Access Compliance Report

Public Rights-of-Way

(Curb Ramps)

Intersection ID: 42916	Main Street: CROSSWALK_DR	Cross Street: HIGHFIELD_CT	Location:	N
ADA ID: 822935E405AF	Ramp Type: PerpDiag	Initial Pass/Fail: Fail	Overall Compliance: No	Severity Score: 21.25
Codes/Mitigation Info/Possible Solution		Field Measurements/Component Compliance

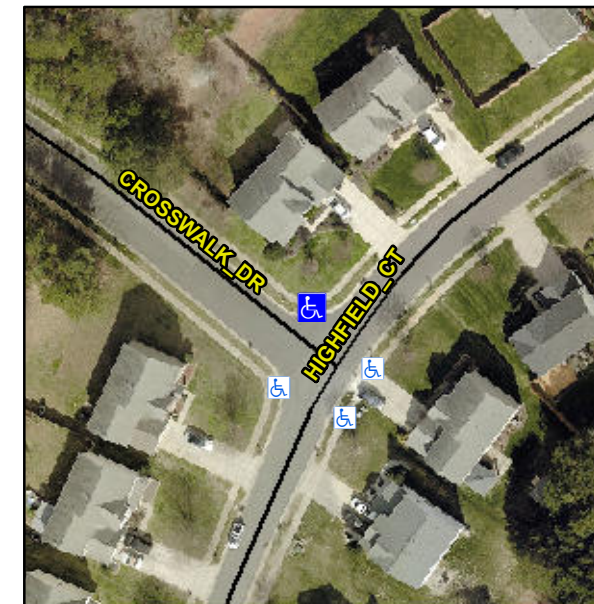
Not Found, R304.5.1, R304.5.3

Compliance	Description	Data	Compliance	Description	Data
N/A	Ramp Length (in)	50.0	Yes	Ramp Slope (%)	5.2
No	Ramp Width (in)	45.5	No	Ramp XSlope (%)	5.1
N/A	Flare Type LT	N/A	N/A	Flare Type RT	N/A
N/A	Flare Slope LT (%)	N/A	N/A	Flare Slope RT (%)	N/A
N/A	Flare Traversable LT?	N/A	N/A	Flare Traversable RT?	N/A
N/A	Landing Length (in)	N/A	N/A	DWS Provided?	N/A
N/A	Landing Width (in)	N/A	N/A	DWS Contrast?	N/A
N/A	Landing Slope (%)	N/A	N/A	DWS Length (in)	N/A
N/A	Landing X Slope (%)	N/A	N/A	DWS Full Width?	N/A
N/A	Landing Curb? (Y/N)	N/A	N/A	DWS Offset (in)	N/A
N/A	Shared Landing?	N/A			
N/A	Gutter Ponding?	N/A	N/A	Gutter Slope (%)	N/A
N/A	Gutter Lip Ht (in)	N/A	N/A	Gutter X Slope (%)	N/A
N/A	Painted X Walk1?	No	N/A	Painted X Walk2?	No
	X Walk 1 Direction	To SW		X Walk 2 Direction	To SE
N/A	X Walk 1 Width (in)	N/A	N/A	X Walk 2 Width (in)	N/A
	X Walk 1 Slope (%)	3.8		X Walk 2 Slope (%)	2.4
	X Walk 1 X Slope (%)	3.5		X Walk 2 X Slope (%)	1.4

N/A	Ramp inside XWalk1?	N/A	N/A	Ramp inside XWalk2?	N/A
	Road Slope (%)	4.3	N/A	Clear Space?	N/A
	Road X Slope (%)	4.9	N/A	Clear Space to XWalk (in)	N/A
N/A	Any Obstructions?	N/A	N/A	Storm Grate/Utility Hazard?	N/A
	Obstruction Type			Storm Grate/Utility Type	
		N/A			N/A
			Yes	Surface Condition? (G/P)	Good

Remove & Replace Curb Ramp With Two New Directional Ramps or Equivalent.
